EPC CASE # 2-99-11 DRB CASE # 2000-4-4

Site Plan For Building Permit

PROJECT TITLE: Furr's Supermarket Inc. Golf Course Road and Paseo del Norte Albuquerque, New Mexico

SHEET TITLE: Site Plan

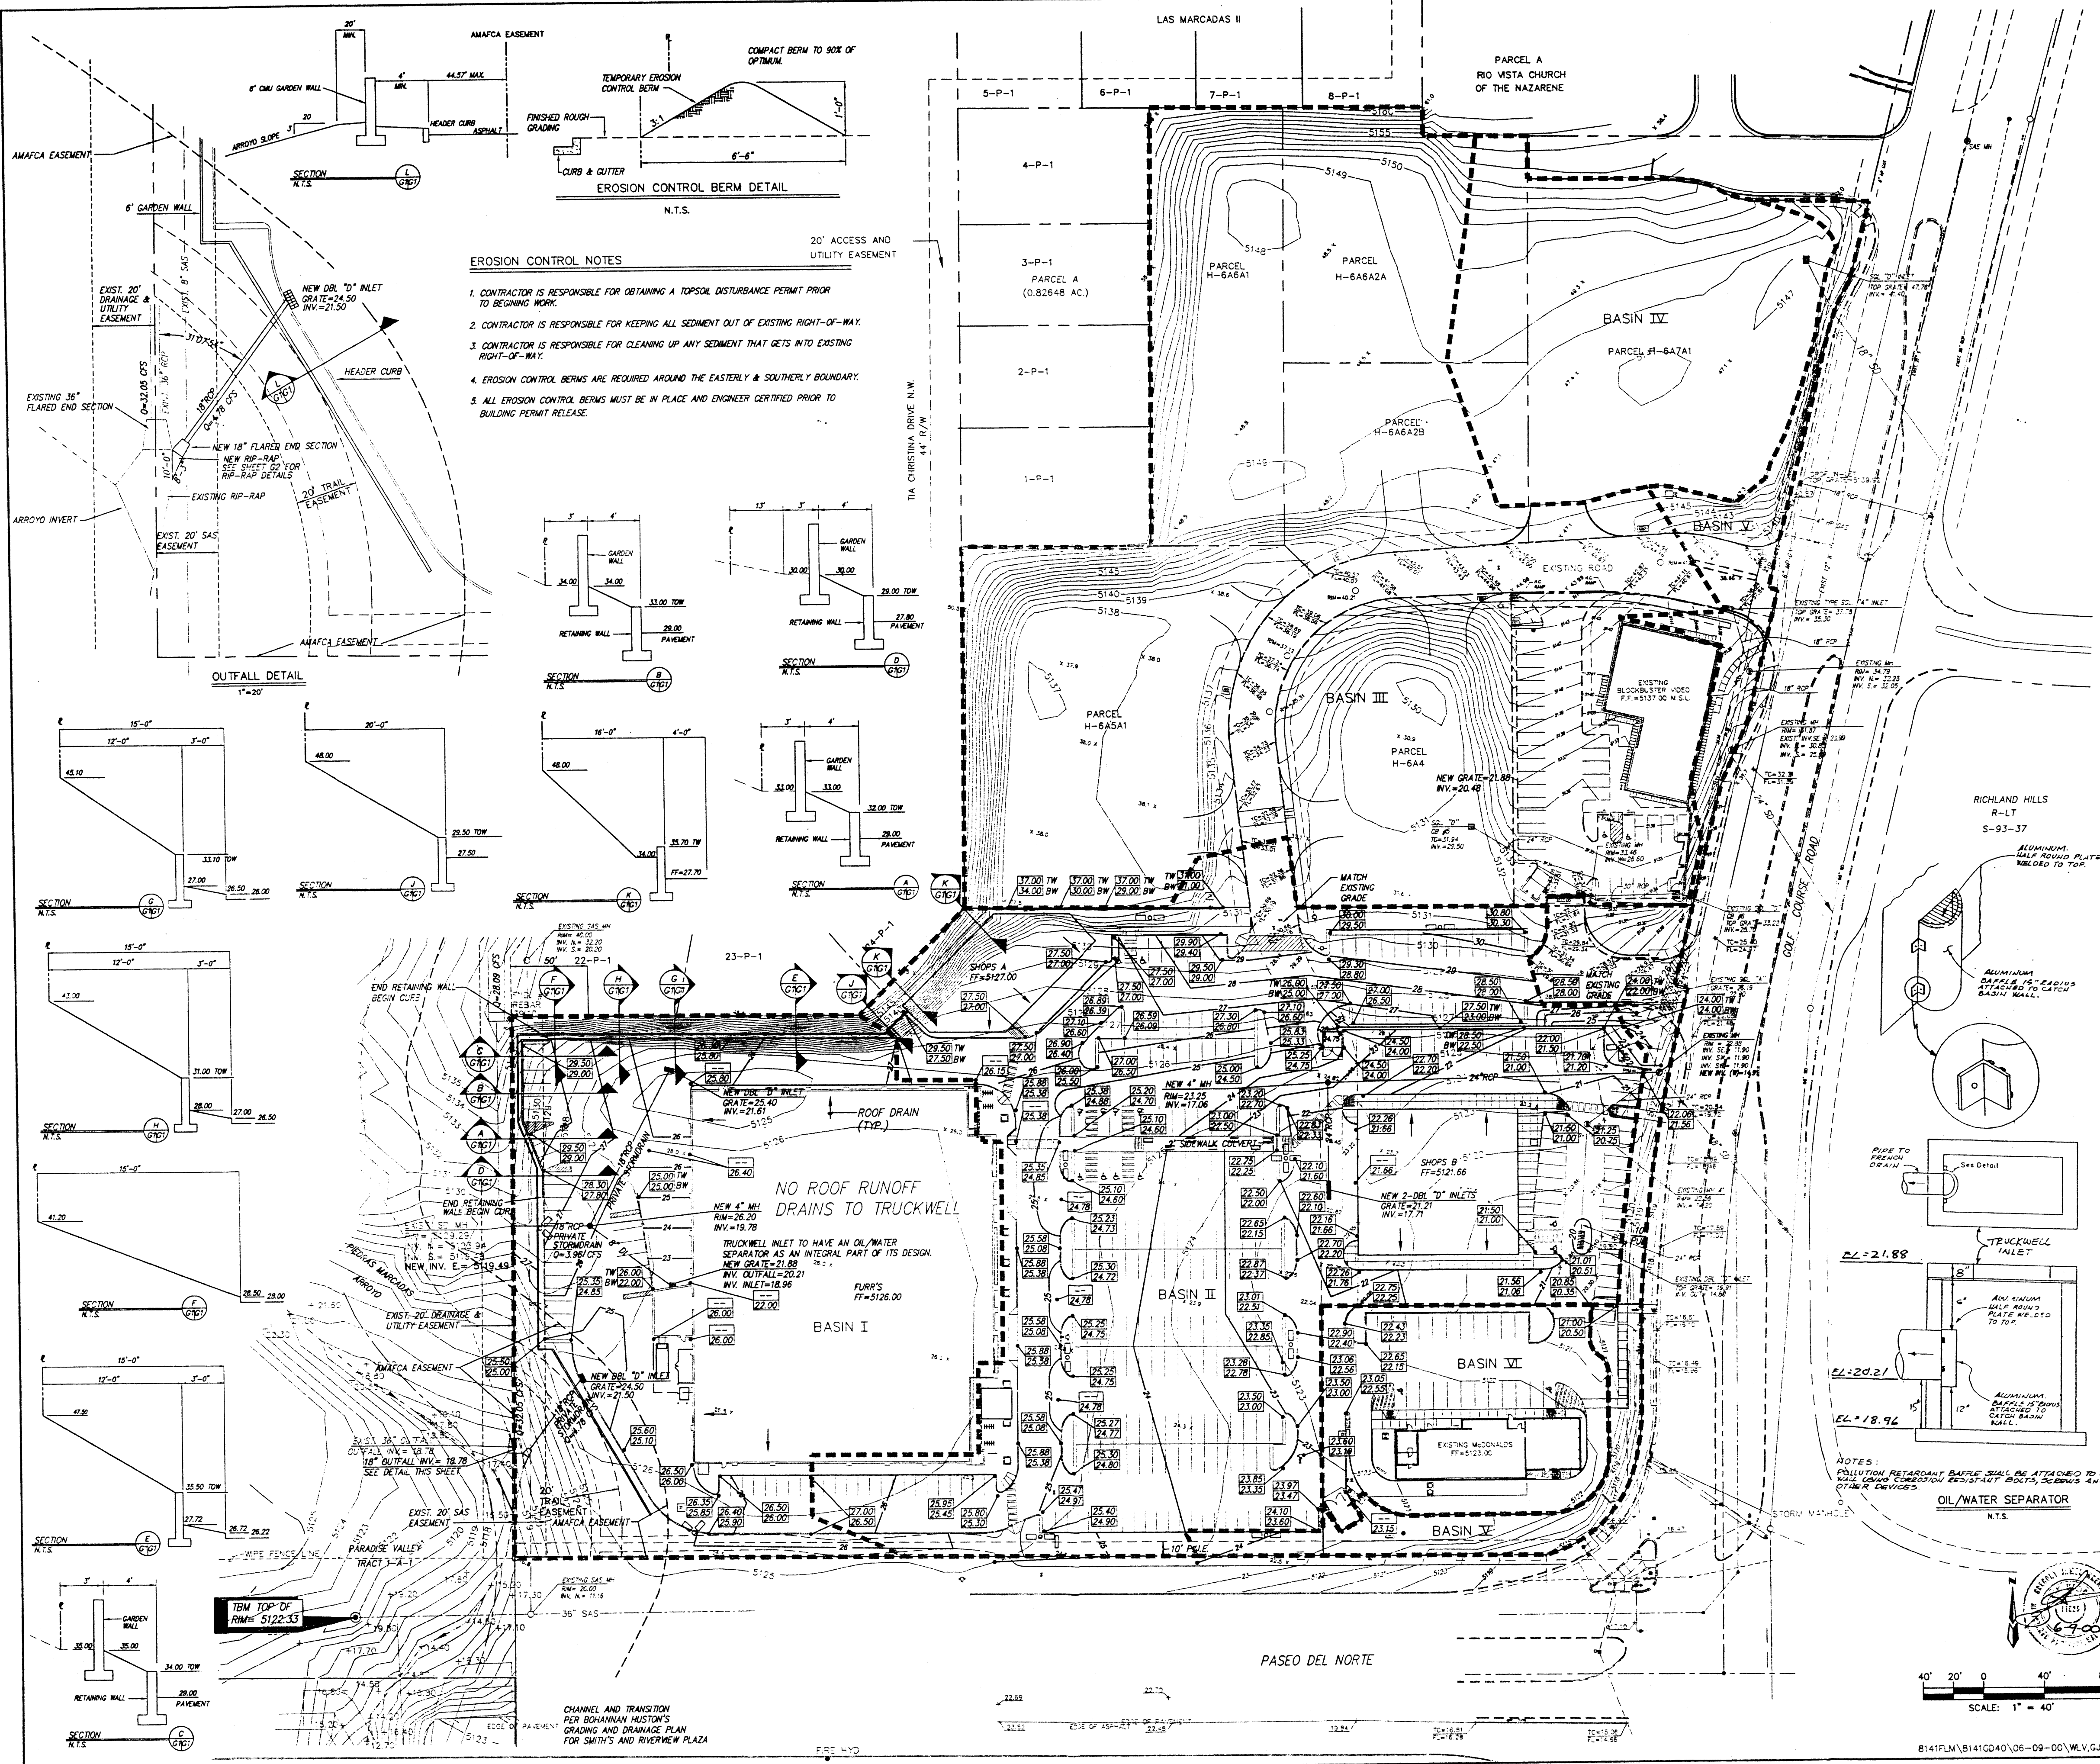
- The following Public Works conditions shall be met before final DRB sign off:
 - Inclusion of a note on the site plan which states that direct access onto Paseo del Norte is prohibited.

- Dedication of right-of-way for and construction of the Piedras Marcadas Trail.
 - Dedication of 78 feet of right-of-way for Paseo del Norte.
 - Construction of required pavement, median, curbs, gutters and 6 foot sidewalk on Paseo del Norte.

- Provision of a 30 foot setback from the front facade of the all building to the drive aisle or parking area. The sidewalk shall be shaded with portals, canopies or shade trees.

- Provide a minimum of 15 foot sidewalk and landscape area along the entire east front of Furr's. The sidewalk shall be shaded with portals, canopies or shade trees at 20 to 30 feet on center in 5 foot by 5 foot planters.

- The following site plan related changes shall be made to the site development plan for building permit before final DRB sign off:
 - Designation of 10% of the parking spaces for multiple occupancy vehicles. The multi-occupancy vehicles should be in shaded areas or areas otherwise considered to be preferred parking.

- Indication of the boundaries of the Northwest Mesa Escarpment Plan Impact Area and View Area overlay zones.
 - A note which indicates that lighting shall have the minimum effect upon adjacent residential areas.

- Provide dimensions of all major site elements, including all sidewalks and pedestrian paths.
 - Revision or elimination of parking spaces on the west side of the site, behind the Furr's supermarket building.

- The drive aisle/parking/landscape configuration on the south side of the Furr's building shall be revised to avoid vehicle overhang. The sidewalk along the south side of Furr's shall be a minimum of 6 feet wide and shall include a connection to the trail along Paseo del Norte.

- The following pedestrian related changes shall be made to the site plan, to the satisfaction of the Planning Department, before final DRB sign off:
 - Provision of sidewalks to the parking spaces on the west and south side of Furr's.

- Revise the pedestrian path between the Furr's and Shop B to make it handicap accessible and consistent with the landscaping plan.
 - There shall be a minimum 15 foot wide sidewalk and landscape area setback from the front facade of the all building to the drive aisle or parking area. The sidewalk shall be shaded with portals, canopies or shade trees.

- Provide a minimum of 15 foot sidewalk and landscape area along the entire east front of Furr's. The sidewalk shall be shaded with portals, canopies or shade trees at 20 to 30 feet on center in 5 foot by 5 foot planters.

- The following bike related changes shall be made to the site plan, to the satisfaction of the Planning Department, before final DRB sign off:
 - Provisions for lockers and showers in the supermarket.

- Inclusion of a bicycle locker between the supermarket and Shop B.
 - Placement of bicycle racks (at least 10 spaces) located on the east side of Furr's, near the trail connection.

- The following site plan related changes shall be made to the site development plan for building permit before final DRB sign off:
 - Designation of 10% of the parking spaces for multiple occupancy vehicles. The multi-occupancy vehicles should be in shaded areas or areas otherwise considered to be preferred parking.

- Indication of the boundaries of the Northwest Mesa Escarpment Plan Impact Area and View Area overlay zones.
 - A note which indicates that lighting shall have the minimum effect upon adjacent residential areas.

- Provide dimensions of all major site elements, including all sidewalks and pedestrian paths.
 - Revision or elimination of parking spaces on the west side of the site, behind the Furr's supermarket building.

- Building massing shall avoid a large dominant building mass. The building massing shall be modified to be compatible with the surrounding area and to portray depth and shadow. Changes may relate to entrances, the integral structure and/or the organization of interior spaces and activities.

- The future trail extension shown along the southern boundary of the site plan and the curbed trail adjacent to the Piedras Marcadas Arroyo shall be constructed to the satisfaction of the DRB.

1 Landscaping Plan
 Scale: 1"=50'-0"

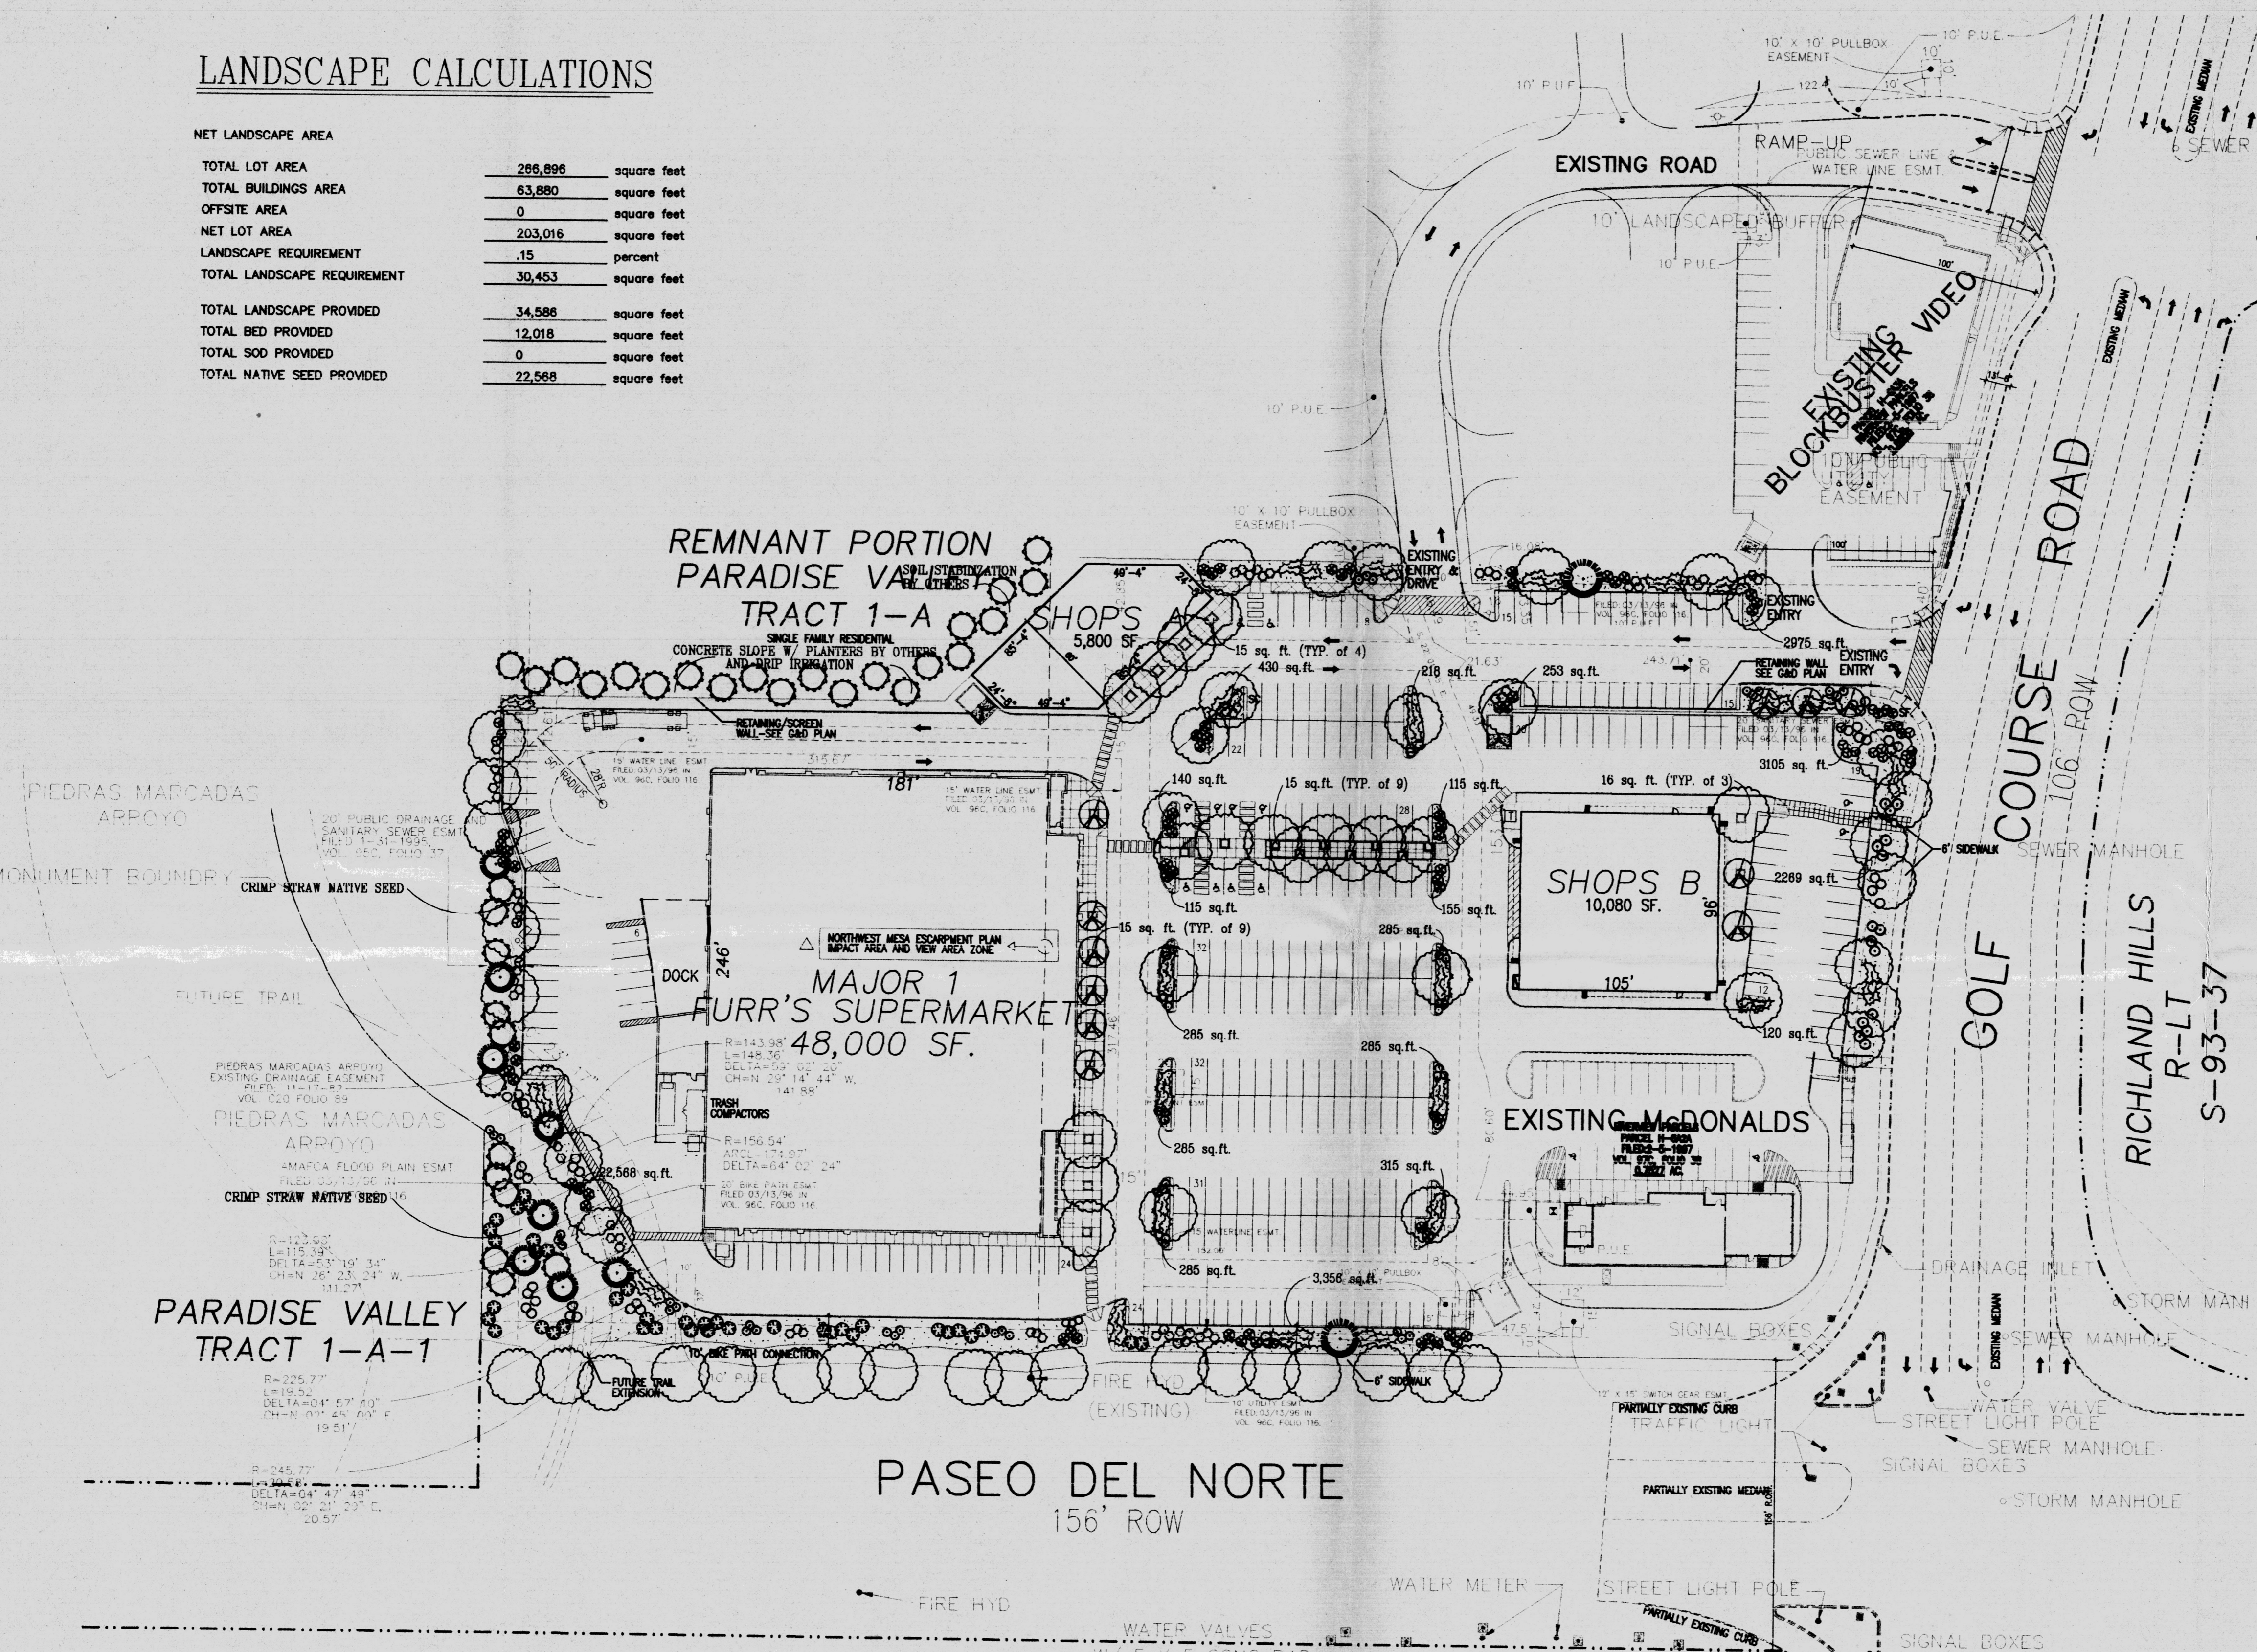
- The following changes to the landscaping plan shall be made to the satisfaction of the Planning Department, before final DRB sign off:
 - Provision of trees along Paseo del Norte in compliance with the street ordinance.

- The landscape buffer along the west side, adjacent to the residential property, shall consist primarily of trees at least eight feet high at the time of planting and capable of reaching a height at maturity of at least 25 feet. Spacing of the trees shall be equal to 75% of the mature canopy diameter of the trees.

- Revision of the landscaping on the pedestrian path between Furr's and Shop B such that it is consistent with the site development plan and that it is handicap accessible.

- The landscaping palette shall be consistent with that of the Northwest Mesa Escarpment Plan.
 - Provision of street trees / landscaping in the areas between the curb and the sidewalks along Paseo del Norte and Golf Course Road.
